DETA & Unique Identifier (UI)

Tire industry perspective and questions

This document aims to summarize the content of 39-06e and relates to the guidelines defined in 35.09 Rev 1.

Scenario: Introduction of a new series of amendment in R117 → R117.03
 Applicable Guideline: Annex 1, Point 4 (Modification of the product needed which **exceeds its type definition**)

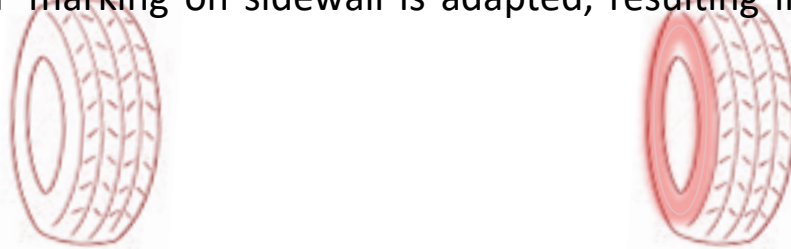
Example: Traction / 3PMSF marking on sidewall is adapted, resulting in a change in 'Type of Tyre'.

PRODUCT:	TIRE 1 (Before)	TIRE 1 (After)
R30 Type Approval #:	E4*30R02/21*987654*00	E4*30R02/21*987654*00
R117 Type Approval #:	E4*117R02/11*123456*00 S2WR2	E4*117R03/00*234567*00 S2WR2X1
Part Marking:	E4 02987654 S2WR2 or E4 02987654 02123456 S2WR2	E4 02987654 S2WR2X1 or E4 02987654 03234567 S2WR2X1
Tire 1 multi-reg Combined #:	UI 01	UI 02
